**DOCUMENT 00 90 10**  
**ADDENDUM No. 1**

- A. The Construction Contract is known as:  
SA009 – CIP – 12TH ST/CENTURY DR – PHASE 1
- B. Date of this Addendum: 2/10/2026

SA009 – CIP – 12TH ST/CENTURY DR – PHASE 1

PP3

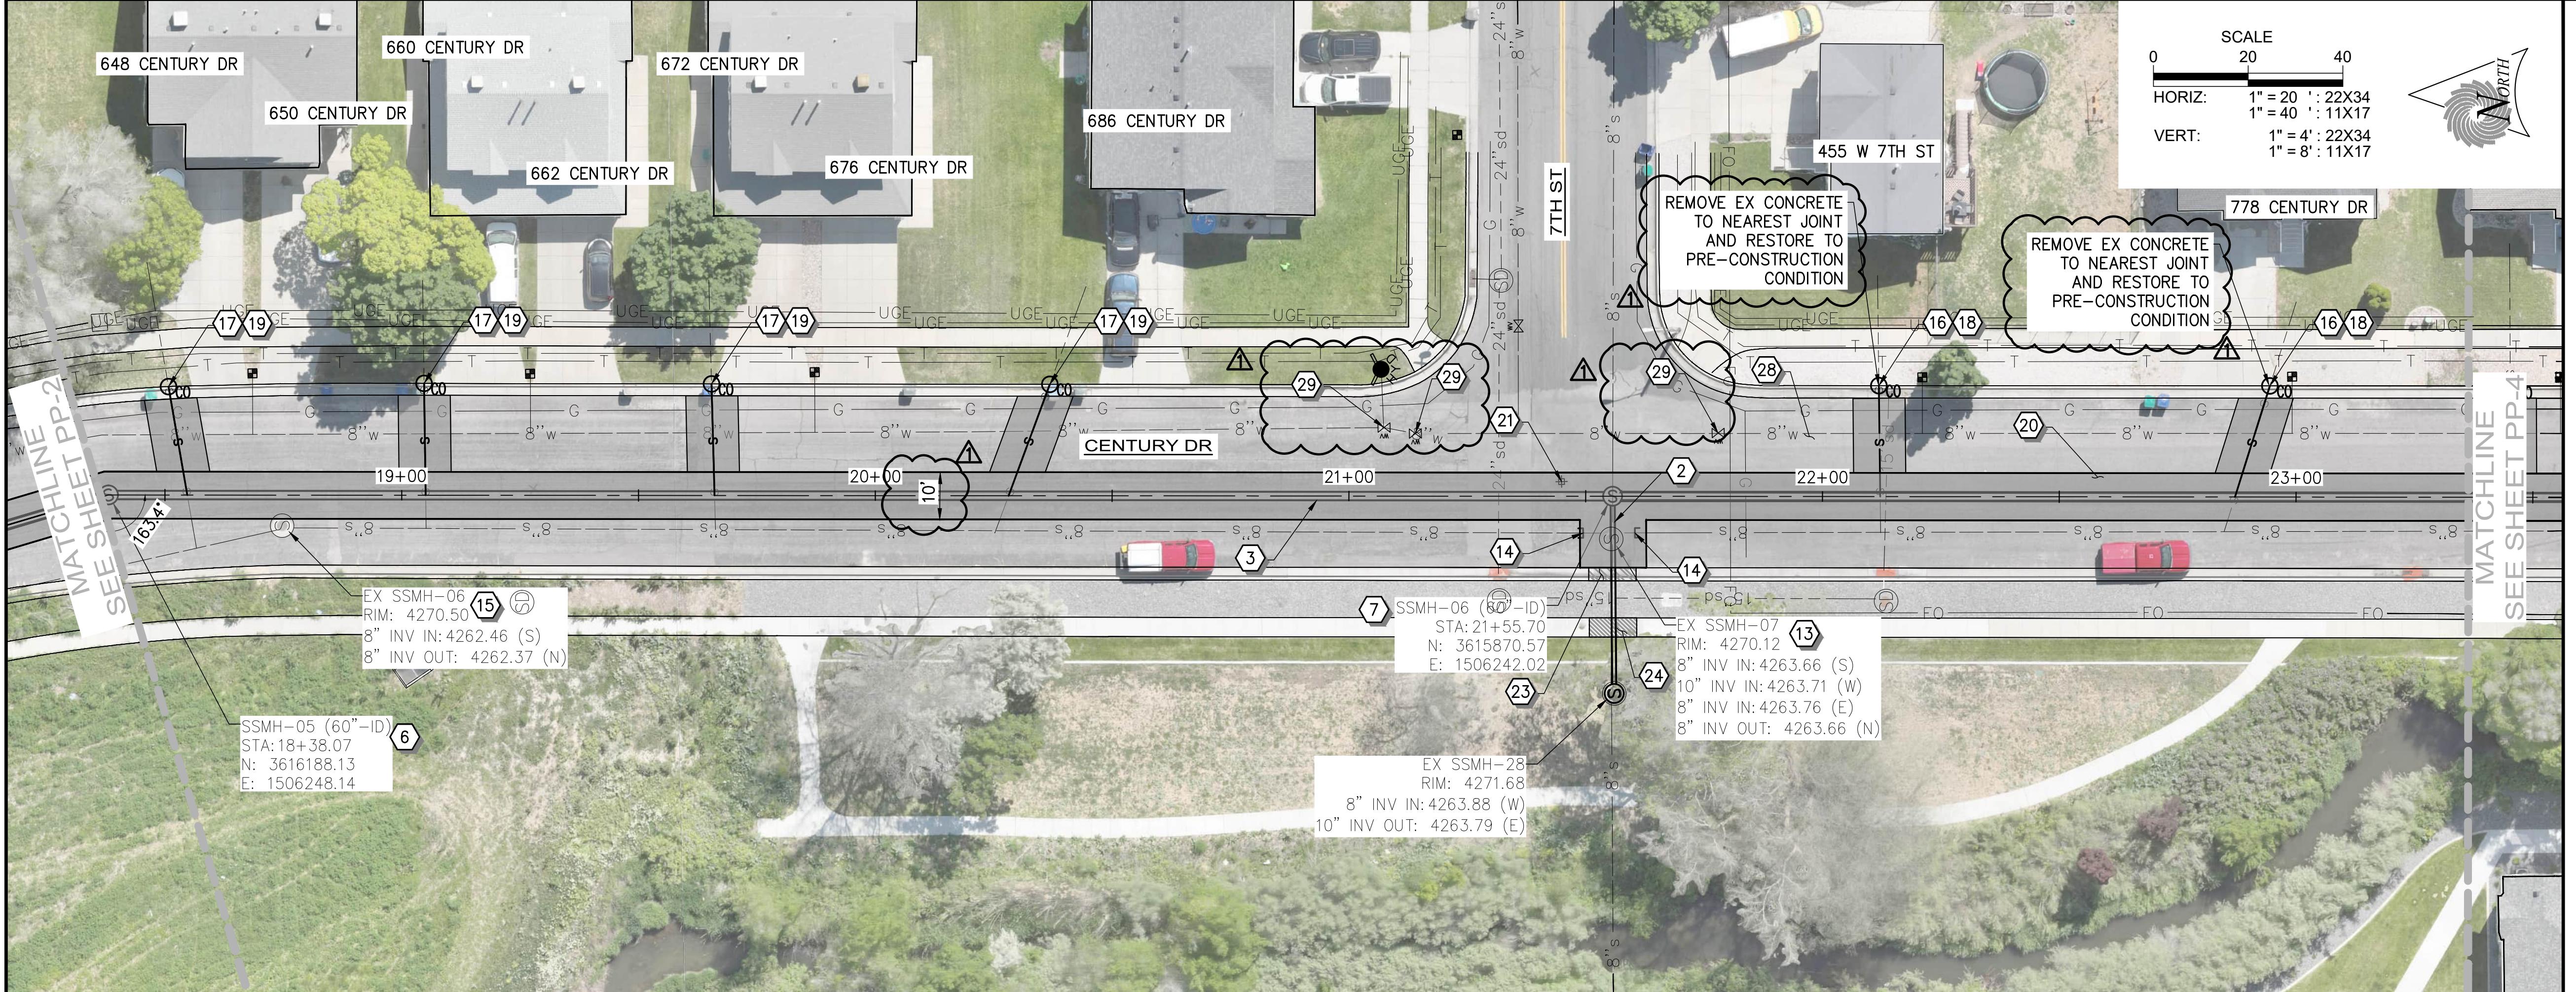
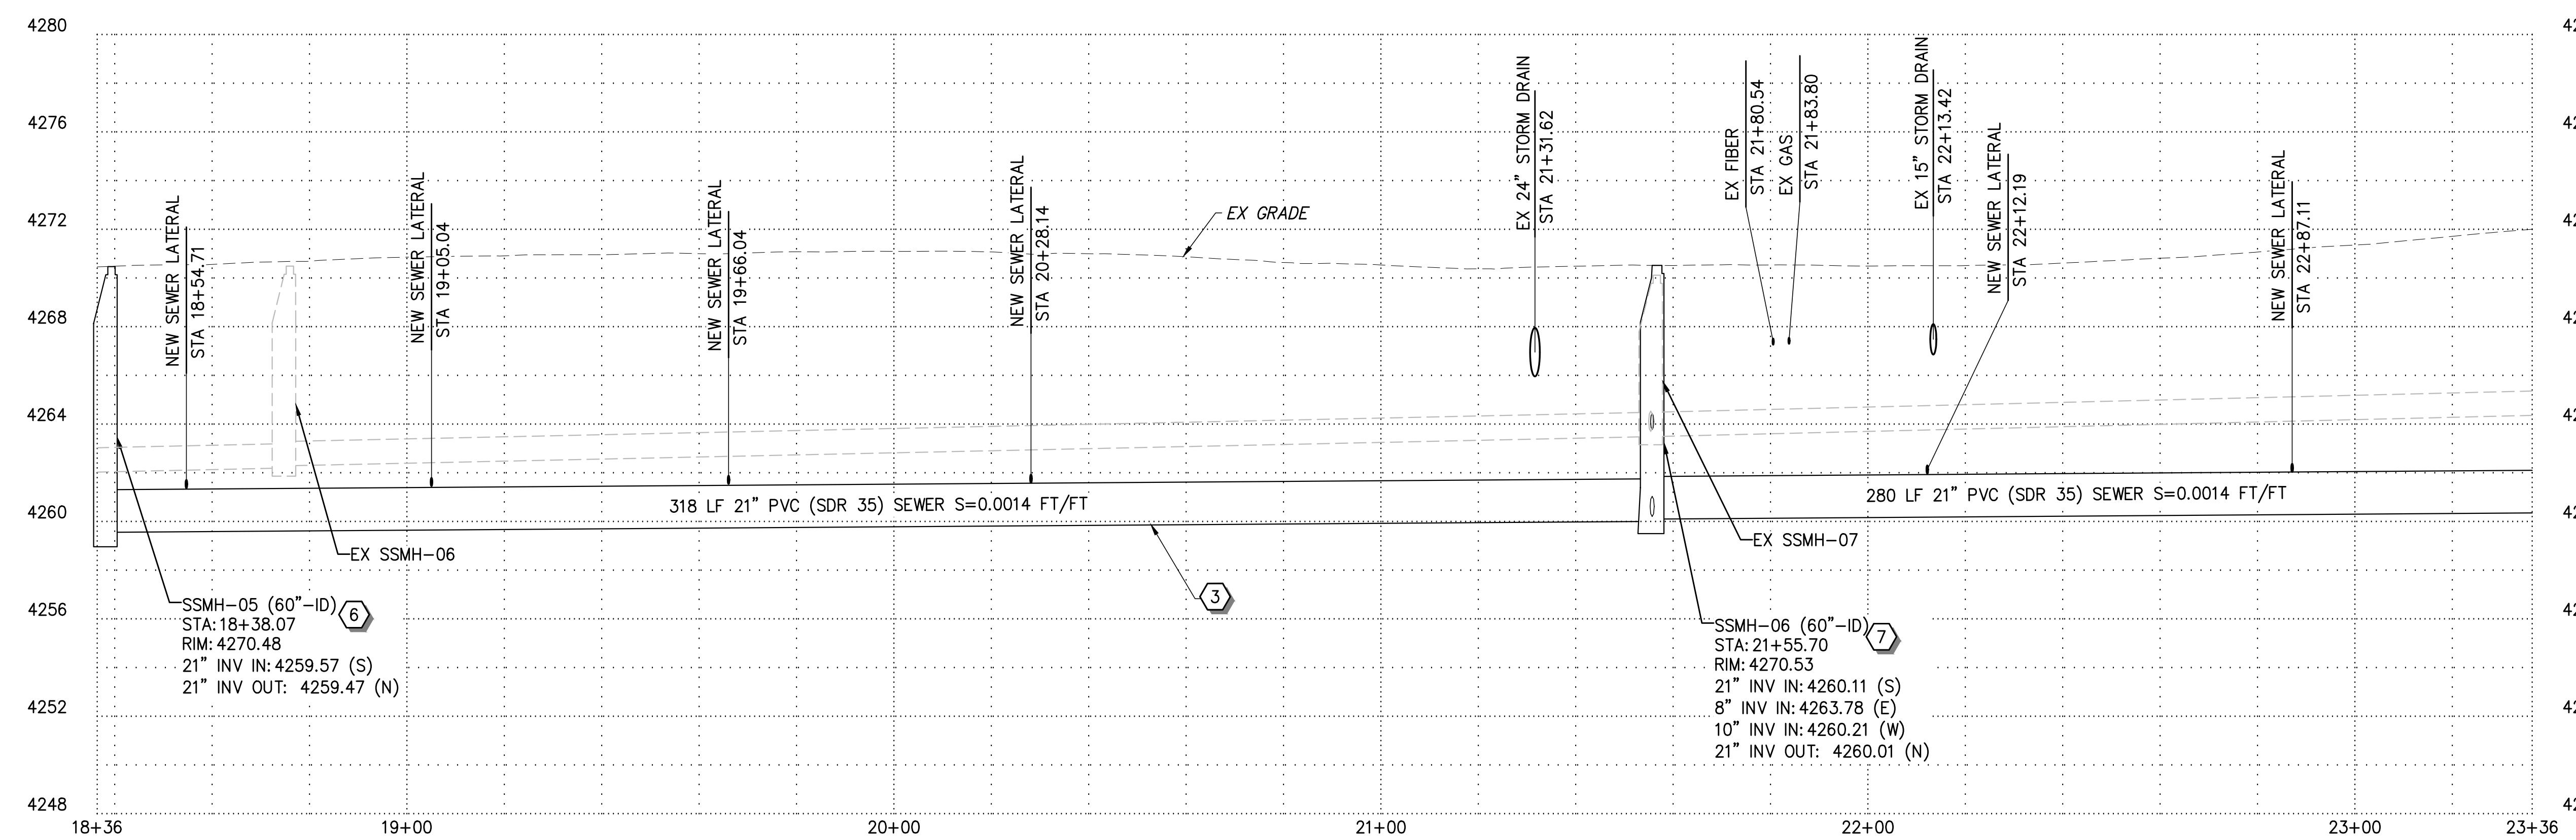
- A. Sheets PP1 to PP7 and C1: Added three new construction notes with accompanying symbols at appropriate locations. Changed construction note 20 from 4" to 6".
- B. Sheet PP1 to PP7: Adjusted width of the asphalt trench and dimension label.
- C. Sheet PP1 and PP3: Added note to applicable cleanouts to remove and restore concrete.

**PP4**

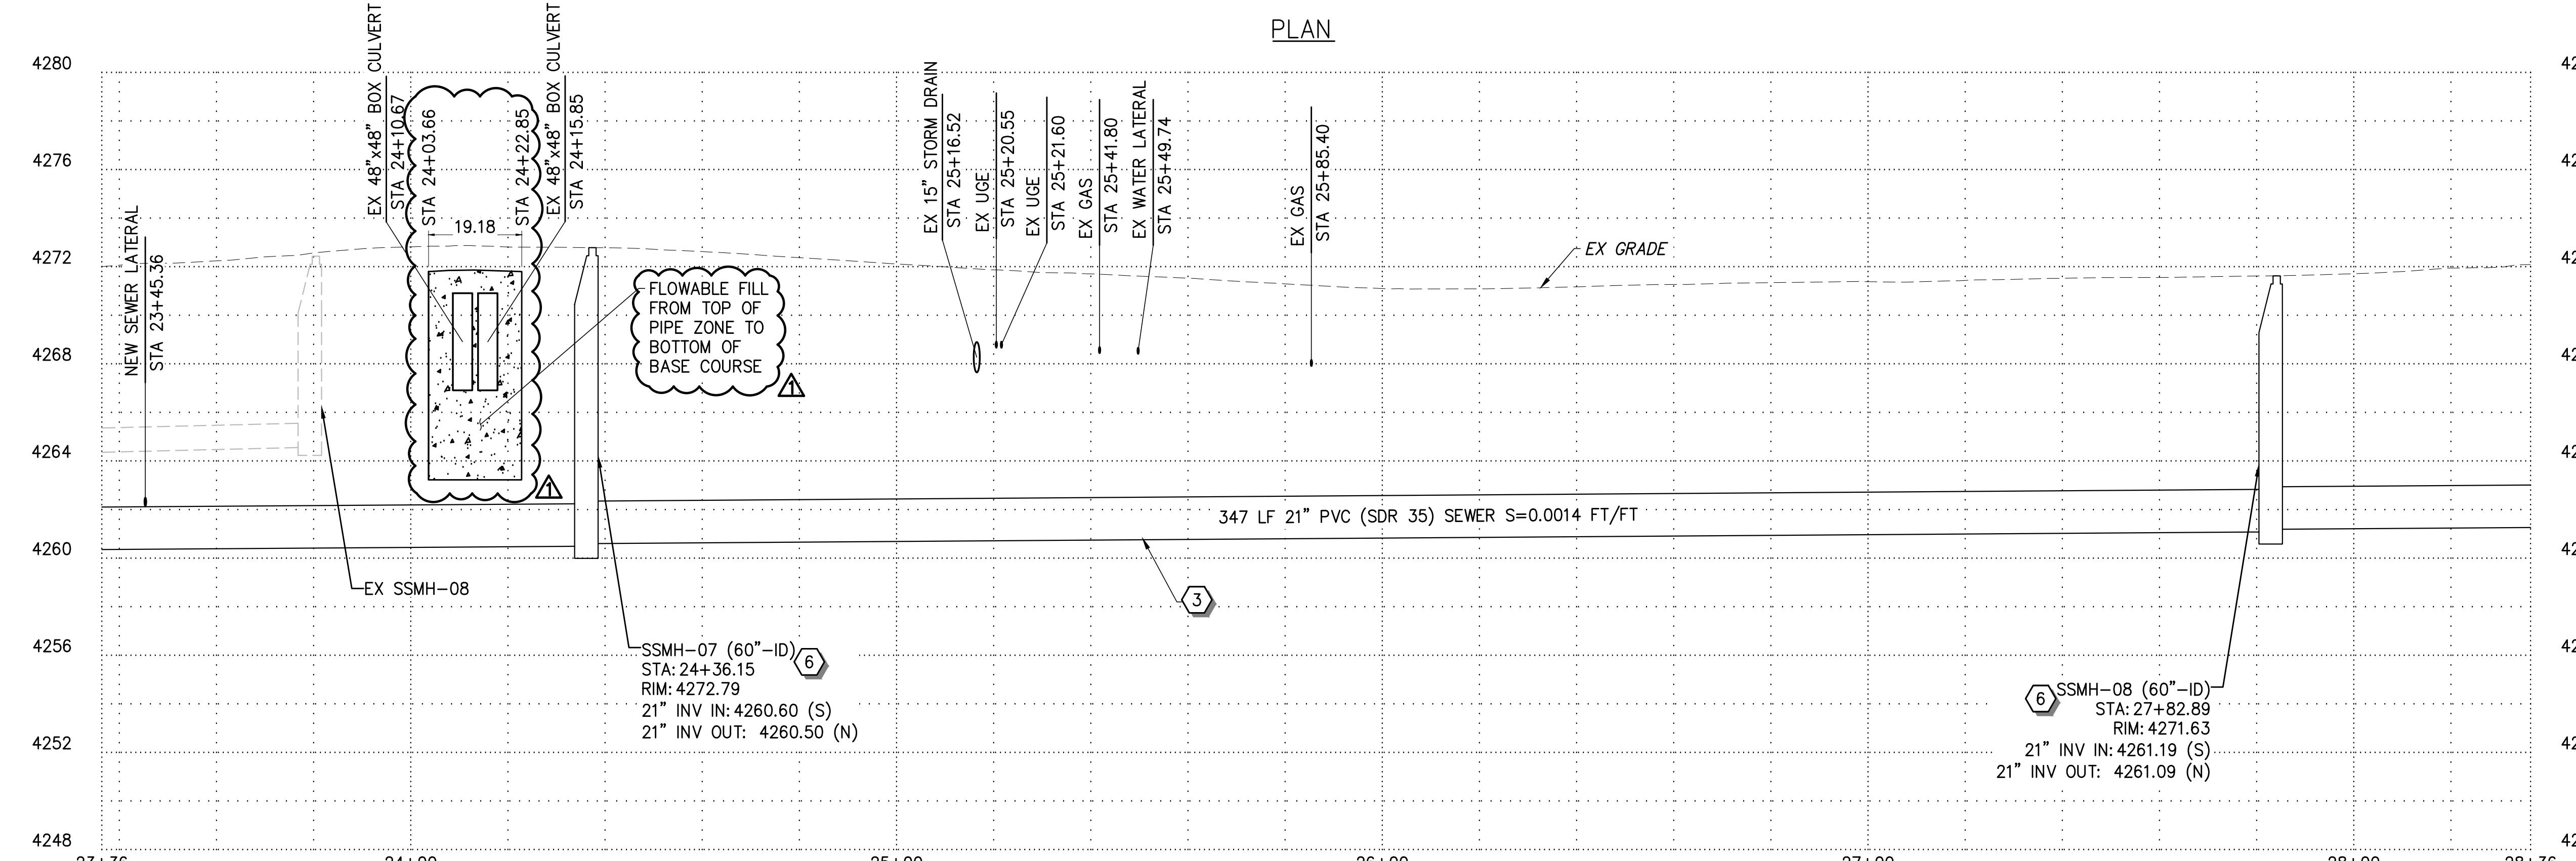
- D. Sheet PP2: Added label with rim and invert information for SSMH-4
- E. Sheet PP4: Added note for flow fill around the Mill Creek Irrigation boxes, including dimensions.
- F. Sheet PP6: Updated keynotes to raise and collar instead of abandon manholes on EX SSMH-10 and EX SSMH-11.
- G. Sheet C1: adjusted dimensions that were not showing proper distances in the profile view, also added the water valve symbols to the plan view.
